**Mineral Sites Proposed for Allocation through the Bournemouth, Dorset and Poole Mineral Sites Plan**

Site Name and reference:	<b>BS02 Marnhull Quarry, Marnhull</b>
Proposed development:	Extraction and processing of building stone
Lead Local Flood Authority comments:	<p>BS02 Marnhull Quarry extension Site Assessment</p> <p>No grounds for objection, subject to detail: The site falls within Flood Zone 1 (low risk – fluvial flooding) according to the Environment Agency’s relevant flood modelling. Equally the site is not shown to be at theoretical risk of surface water flooding, by relevant mapping, although it is within 200m (west) of significant flood risk (both fluvial &amp; surface water ) associated with a tributary of the Main River Stour (Chilvrick’s Brook – Ordinary Watercourse).</p> <p>Whilst the site would appear to be elevated well above this flood risk, a site specific strategy for surface water management should be requested to ensure that proposed land use does not exacerbate such risk downstream. As such the proposed activity should comply with the recommendations of the NPPF. Prior Land Drainage Consent may be required from DCC as relevant LLFA, for any works offering

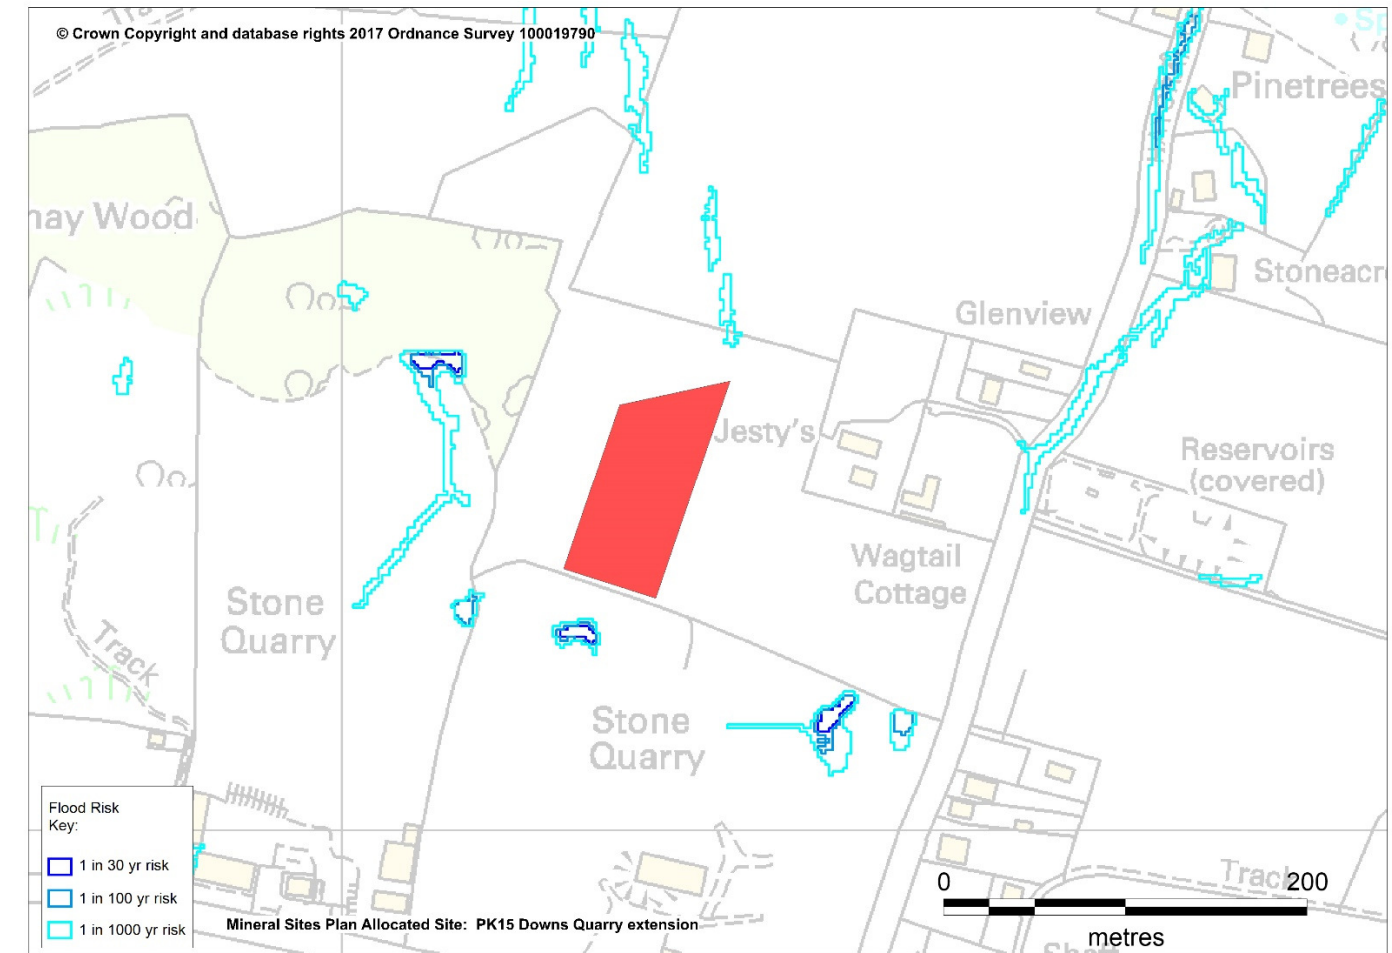
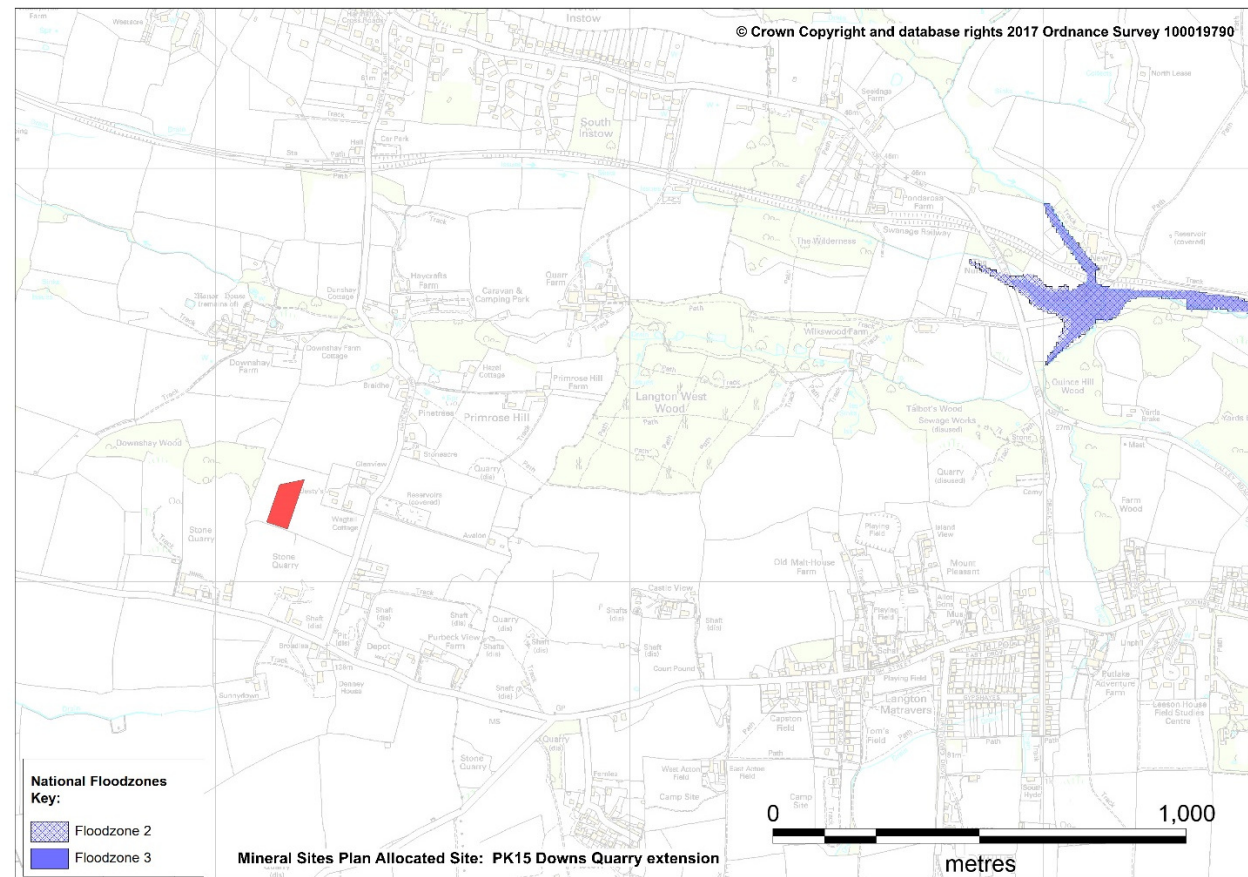
Site Name and reference:	<b>PK15 – Downs Quarry Extension, Langton Matravers</b>
Proposed development:	Extraction of Purbeck Stone
Lead Local Flood Authority comments:	<p>PK15 Downs Quarry extension Site Assessment</p> <p>No grounds for objection, subject to detail: The site falls entirely within Flood Zone 1 (low risk – fluvial flooding) according to the Environment Agency’s relevant flood modelling, and is not shown to be at any theoretical risk of surface water flooding, by relevant mapping. Given the prevailing geology, it is likely that surface water would be managed via infiltration.</p> <p>A site specific strategy for surface water management is a requirement for all development (NPPF), as no off site worsening should be offered. Both surface and ground water derived from the site is assumed to migrate north towards the Downshay Farm grouping of properties. Prior Land Drainage Consent may be required from DCC as relevant LLFA, for any works offering an obstruction to flow within a channel with the status of Ordinary Watercourse.</p>

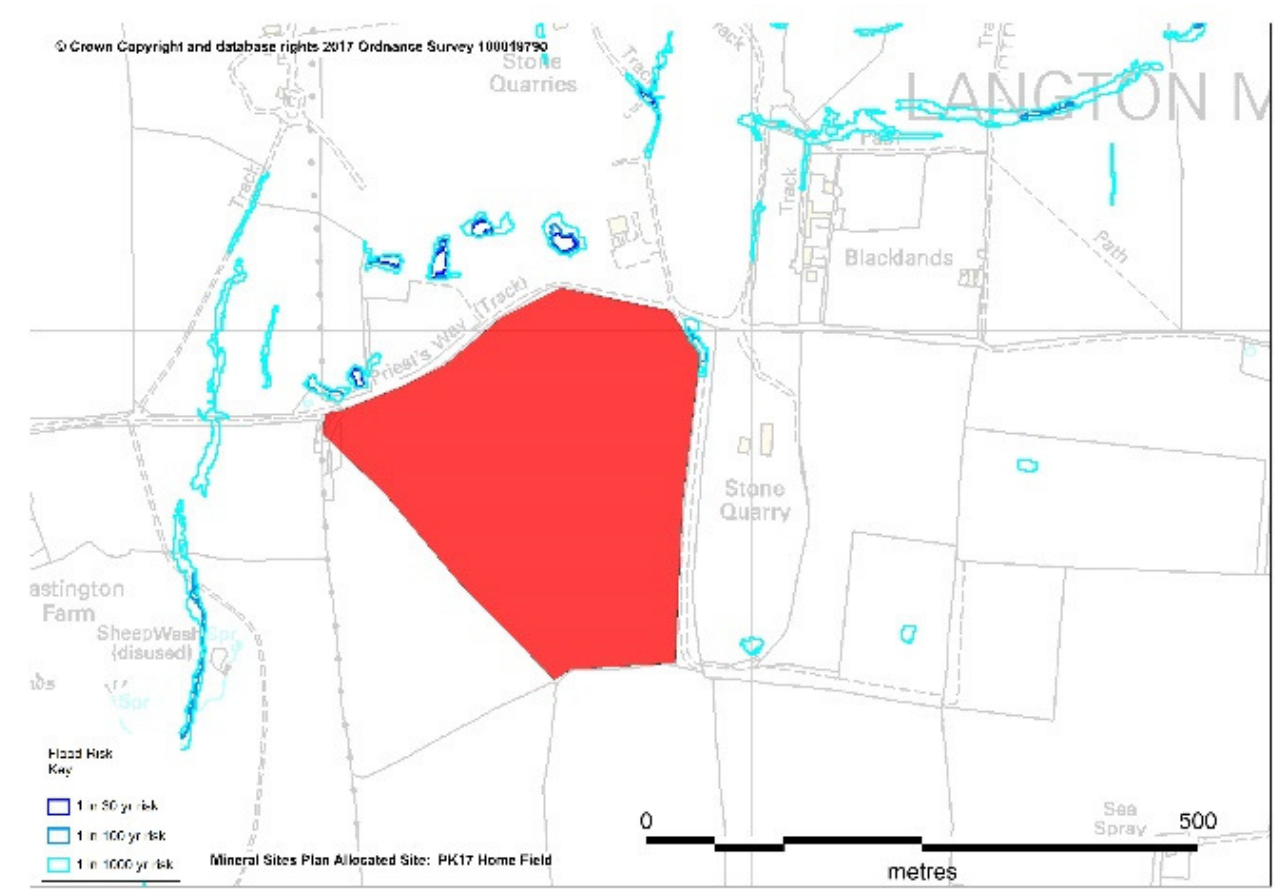
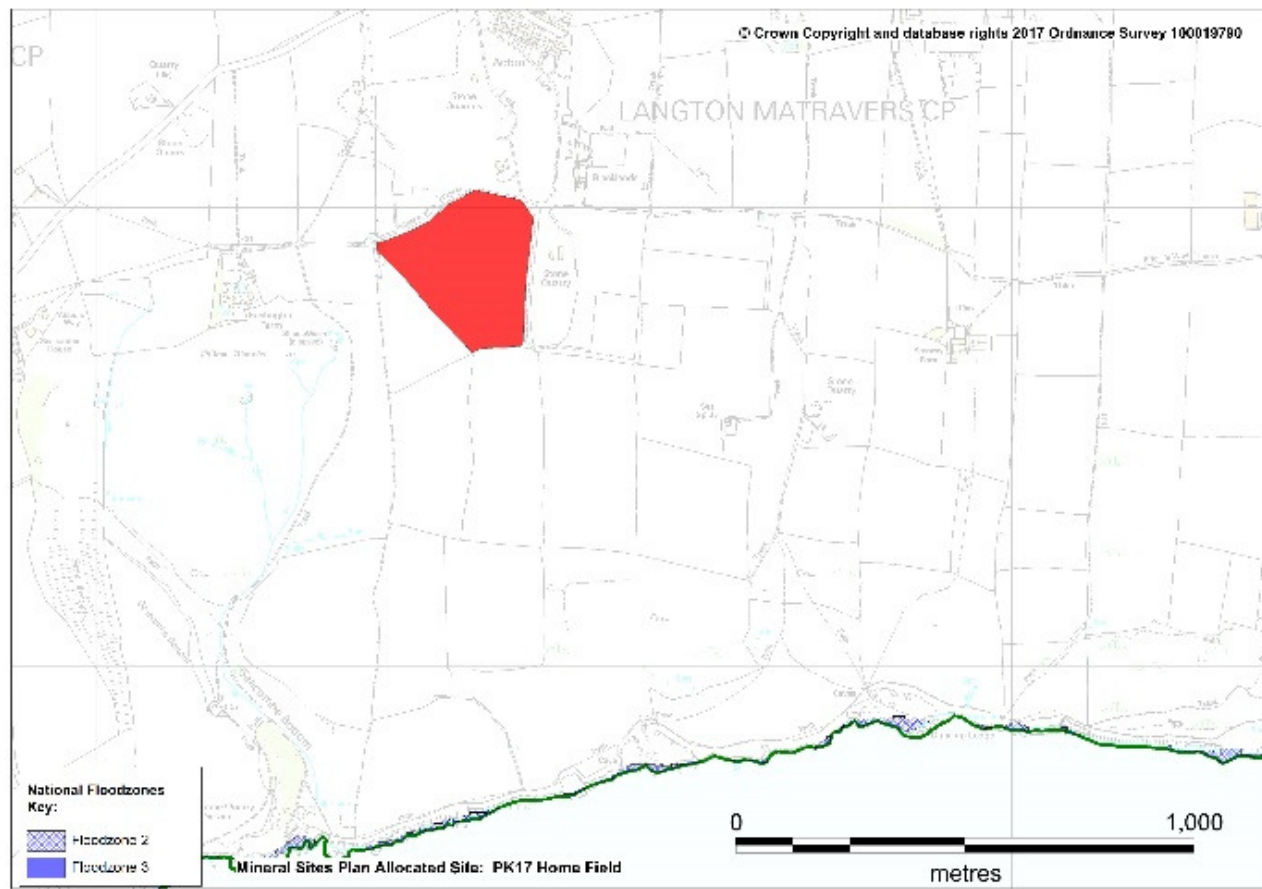
Site Name and reference:	<b>PK17 – Home Field, Worth Matravers</b>
Proposed development:	Allocation of an area within which future Purbeck Stone extraction can take place.
Lead Local Flood Authority comments:	<p>PK17 Home Field Site Assessment</p> <p>No grounds for objection, subject to detail: The site falls entirely within Flood Zone 1 (low risk – fluvial flooding) according to the Environment Agency’s relevant flood modelling, and is not shown to be at any theoretical risk of surface water flooding, by relevant mapping. Given the prevailing geology and fall in ground levels, it is likely that surface water would be managed via infiltration, or controlled discharge to an adjoining stream.</p> <p>Whilst a site specific strategy for surface water management is a requirement for all development (NPPF) no off site worsening is anticipated. Prior Land Drainage Consent may be required from DCC as relevant LLFA, for any works offering an obstruction to flow within a channel with the status of Ordinary Watercourse.</p>

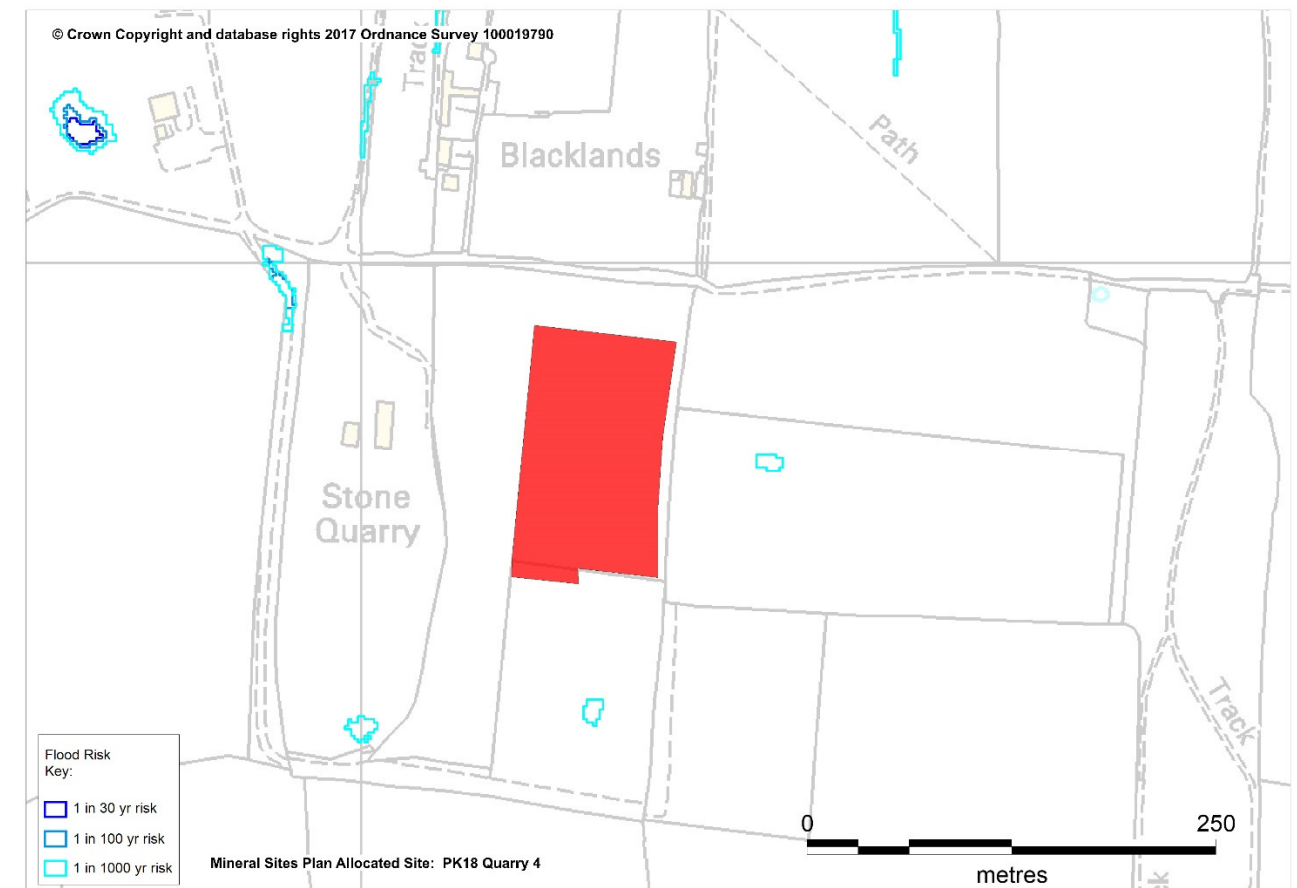
Site Name and reference:	<b>PK18 – Quarry 4 Extension, Acton</b>
Proposed development:	Extraction of Purbeck Stone
Lead Local Flood Authority comments:	<p>PK18 Quarry 4 extension Site Assessment</p> <p>No grounds for objection, subject to detail: The site falls entirely within Flood Zone 1 (low risk – fluvial flooding) according to the Environment Agency’s relevant flood modelling, and is not shown to be at any theoretical risk of surface water flooding, by relevant mapping. Given the prevailing geology and fall in ground levels, it is likely that surface water would be managed via infiltration.</p> <p>Whilst a site specific strategy for surface water management is a requirement for all development (NPPF) no off site worsening is anticipated. Prior Land Drainage Consent may be required from DCC as relevant LLFA, for any works offering an obstruction to flow within a channel with the status of Ordinary Watercourse.</p>

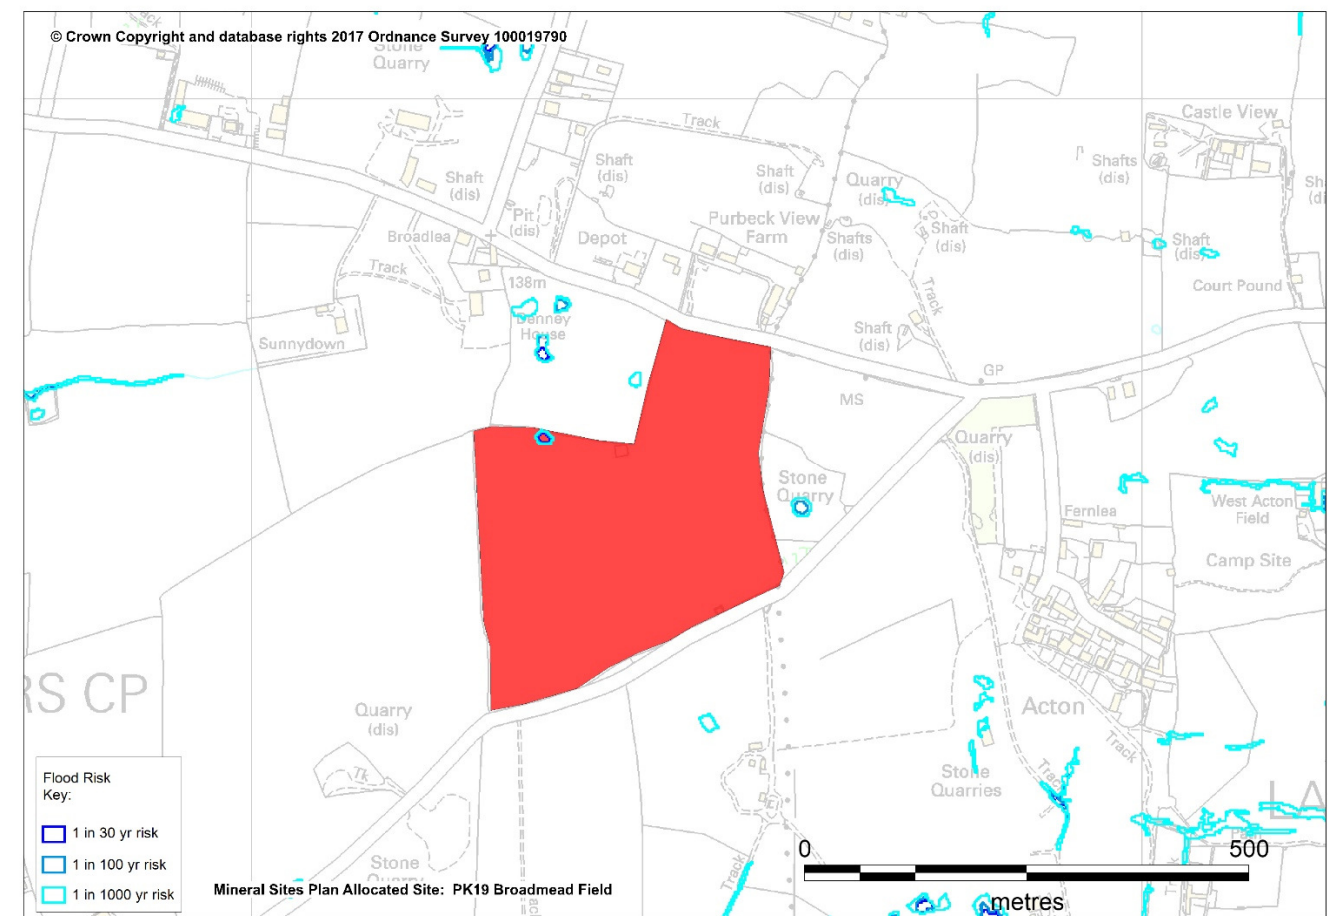
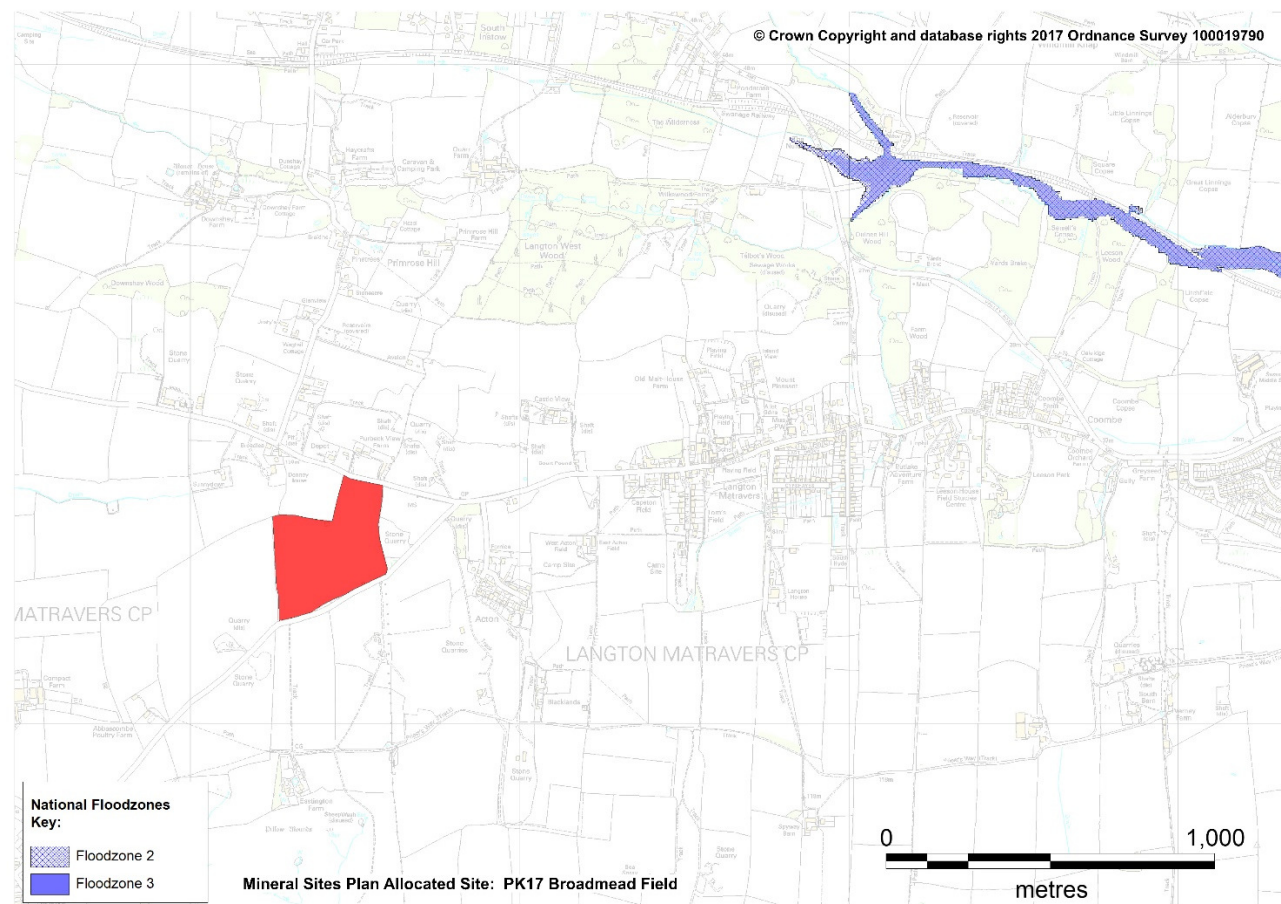
Site Name and reference:	<b>PK19 – Broadmead, Acton</b>
Proposed development:	Allocation of an area within which future Purbeck Stone extraction can take place.
Lead Local Flood Authority comments:	<p>PK19 Broadmead Quarry Site Assessment</p> <p>No grounds for objection, subject to detail: The site falls entirely within Flood Zone 1 (low risk – fluvial flooding) according to the Environment Agency’s relevant flood modelling, and is not shown to be at any theoretical risk of surface water flooding, by relevant mapping. Given the prevailing geology, it is likely that surface water would be managed largely via infiltration.</p> <p>A site specific strategy for surface water management is a requirement for all development (NPPF), as no off site worsening should be offered. Both surface and ground water derived from the site is assumed to migrate north towards the Sunnydown grouping of properties. Prior Land Drainage Consent may be required from DCC as relevant LLFA, for any works offering an obstruction to flow within a channel or ditch with the status of Ordinary Watercourse.</p>
